Access Compliance Report Public Rights-of-Way (Curb Ramps)

Intersection ID: 18177 Main Street: OLD PINEVILLE RD **Cross Street: SCHOLTZ RD** Location: NW ADA ID: 1AEA32454B18 Ramp Type: PerpDiag Initial Pass/Fail: Fail **Overall Compliance: No** Severity Score: 33.75

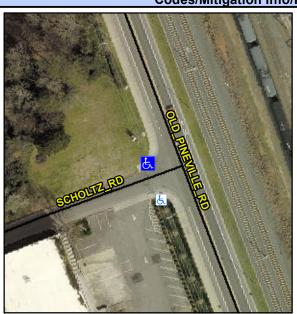
Field Measurements/Component Compliance					
Compliance Description		Data	Comp	liance Description	Data
N/A	Ramp Length (in)	72.0	Yes	Ramp Slope (%)	5.1
No	Ramp Width (in)	47.0	No	Ramp XSlope (%)	11.2
N/A	Flare Type LT	N/A	N/A	Flare Type RT	N/A
N/A	Flare Slope LT (%)	N/A	N/A	Flare Slope RT (%)	N/A
N/A	Flare Traversable LT?	N/A	N/A	Flare Traversable RT?	N/A
N/A	Landing Length (in)	N/A	N/A	DWS Provided?	N/A
N/A	Landing Width (in)	N/A	N/A	DWS Contrast?	N/A
N/A	Landing Slope (%)	N/A	N/A	DWS Length (in)	N/A
N/A	Landing X Slope (%)	N/A	N/A	DWS Full Width?	N/A
N/A	Landing Curb? (Y/N)	N/A	N/A	DWS Offset (in)	N/A
N/A	Shared Landing?	N/A			
N/A	Gutter Ponding?	N/A	N/A	Gutter Slope (%)	N/A
N/A	Gutter Lip Ht (in)	N/A	N/A	Gutter X Slope (%)	N/A
N/A	Painted X Walk1?	No	N/A	Painted X Walk2?	No
	X Walk 1 Direction	To S		X Walk 2 Direction	To E
N/A	X Walk 1 Width (in)	N/A	N/A	X Walk 2 Width (in)	N/A
	X Walk 1 Slope (%)	2.5		X Walk 2 Slope (%)	8.7

X Walk 1 X Slope (%)	8.1		X Walk 2 X Slope (%)	1.2
N/A	Ramp inside XWalk1?	N/A	N/A	Ramp inside XWalk2?	N/A
	Road Slope (%)	7.6	N/A	Clear Space?	N/A
	Road X Slope (%)	5.2	N/A	Clear Space to XWalk (in)	N/A
N/A	Any Obstructions?	N/A	N/A	Storm Grate/Utility Hazard?	N/A
	Obstruction Type			Storm Grate/Utility Type	
		N/A			N/A
			Yes	Surface Condition? (G/P)	Good
100

Possible Solutions: **Remove & Replace Curb Ramp With Two New Directional Ramps or** Equivalent. Surveyor Notes: N/A PROW/ADA: Not Found, R304.5.1, R304.5.3
